CERTIFICATE OF APPROPRIATENESS

Property: 642 Heights Boulevard, Lot 23, Block 277, Houston Heights Subdivision. The property includes a historic 1,235 square foot one-story brick veneered residence situated on a 7,500 square foot (50'x150') interior lot.

Proposal: Alteration – Revision. The property received a COA for foundation repair and brick stabilization on June 19, 2014 and a COA for a rear two-story addition on October 23, 2014. All original materials were to remain as stipulated in the previously approved COAs.

HAHC Action: Approved – This COA explicitly applies only to the remediation work and not to the inappropriate removal of historic materials itself

WEST ELEVATION – FRONT FACING HEIGHTS BOULEVARD

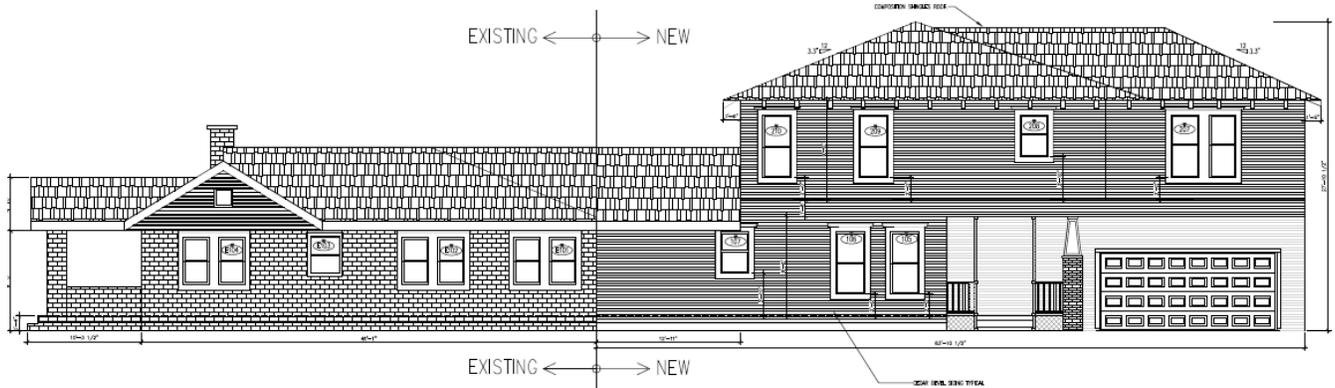
Front Elevation: The residence features two pairs of windows as well as an additional window. One pair has been removed and retained on site and will be reinstalled. The other windows are still in place and are to be retained and repaired. The addition was approved to have two pairs of windows but will now have two single windows on the second floor. See drawings for more detail.

SOUTH SIDE ELEVATION

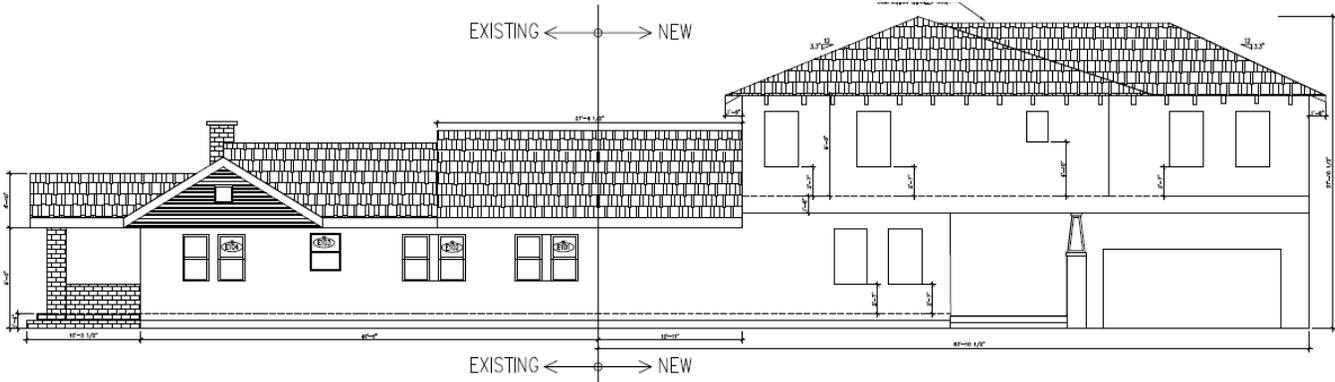
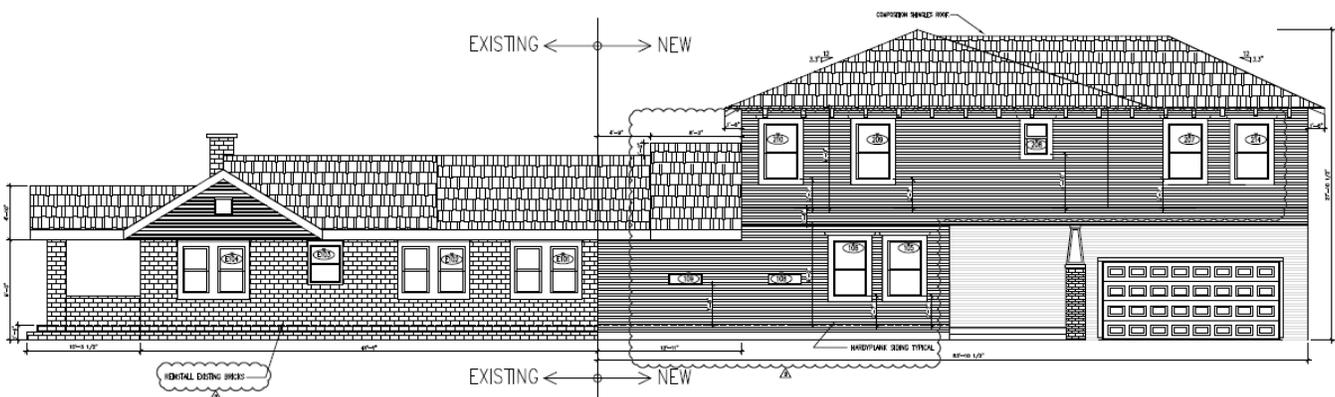
Side Elevation: The original house features seven windows, all of which remain in place and are to be retained and repaired. The addition was approved to have three windows on the first floor and five windows on the second floor. Two of the proposed windows will be replaced with narrow horizontal fixed windows while the windows on the second story will remain as approved. See drawings for more detail.

NORTH SIDE ELEVATION

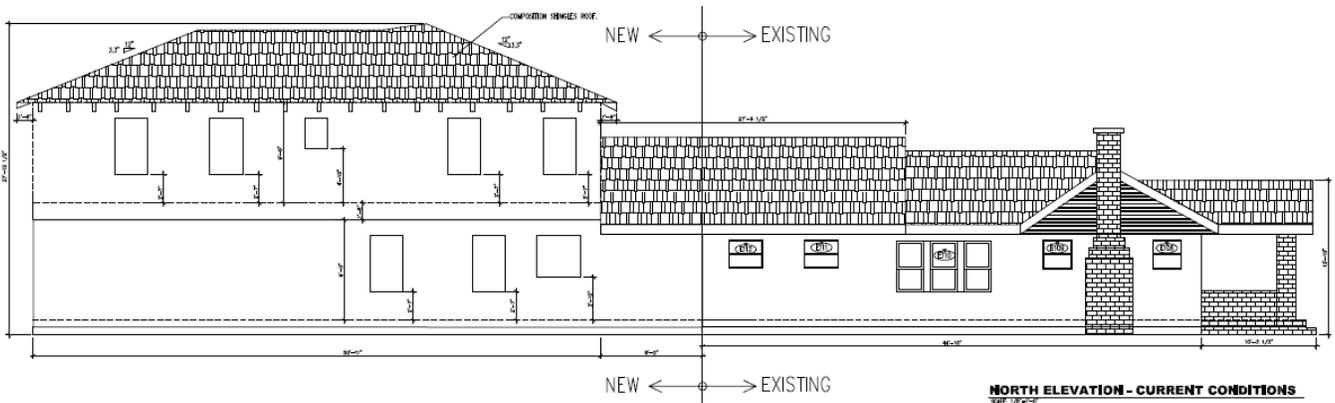
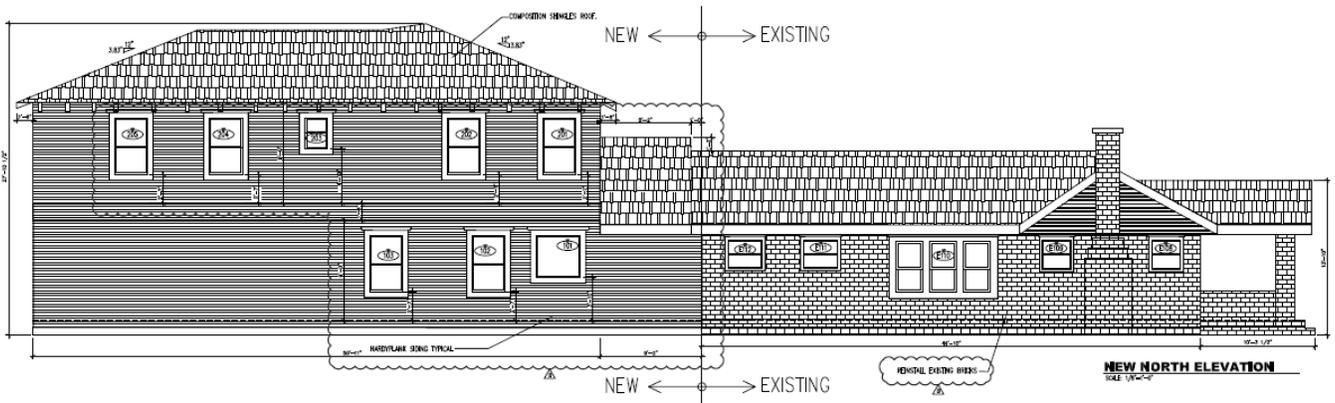
Side Elevation: The original house features seven windows, all of which remain in place and are to be retained and repaired. The addition was approved to have three windows on the first floor and five on the second floor. Their locations and sizes have been altered slightly.

ROOF PLAN

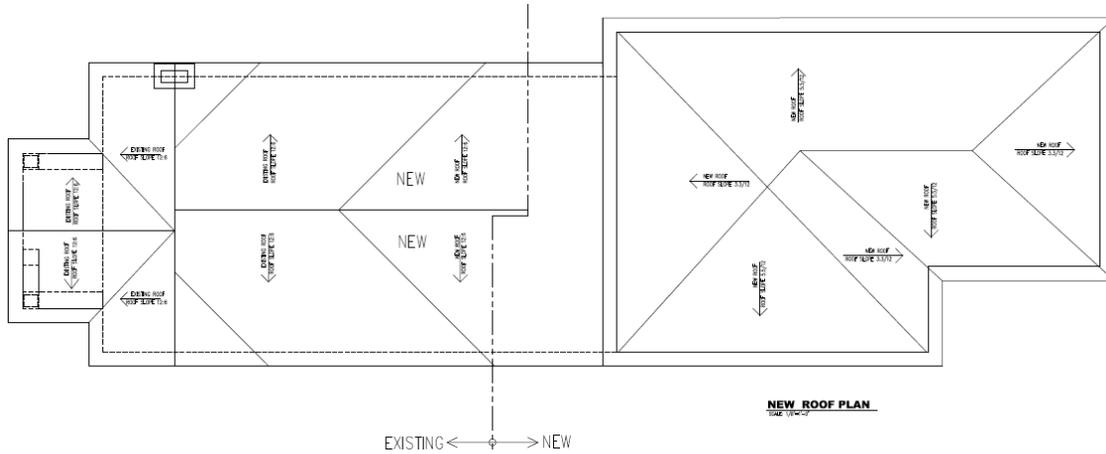
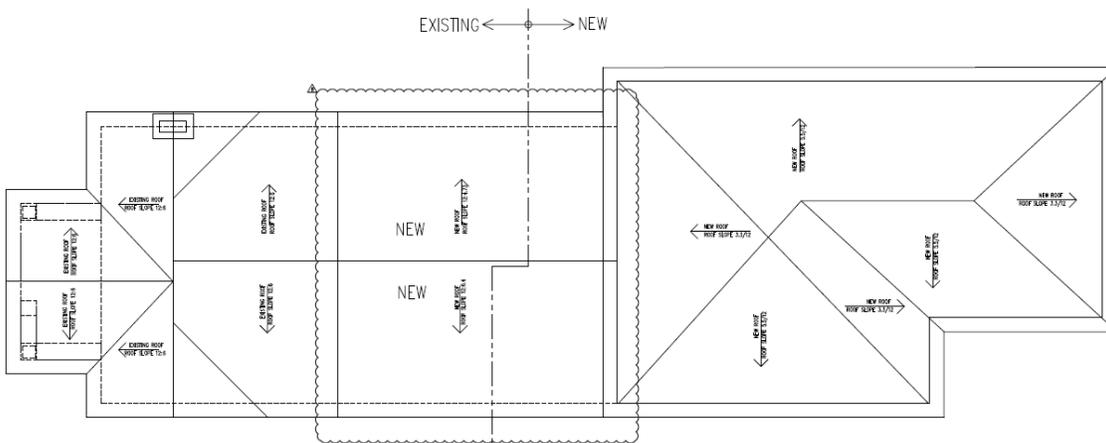
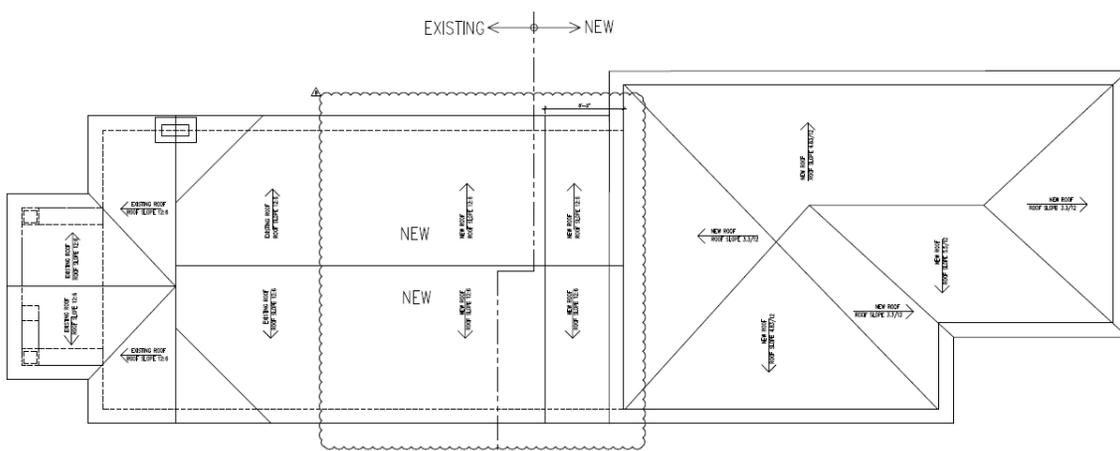
Roof: As part of the approved COA for the addition, the existing roof of the original structure was to remain. However, during construction, a portion of the original roof was removed and reconstructed at an increased height of 1'-2". The new unapproved roof encroached 18'-2½" into the original structure on the north elevation and 14'-5½" on the south elevation.

The current roof, not built to plan, will be removed and replaced with a roof that matches the original height and configuration. The raised roof of the addition will now begin 1'-0" behind the original rear wall of the house on the north elevation and 4'-9" behind the original rear wall on the south. See drawings for more detail.
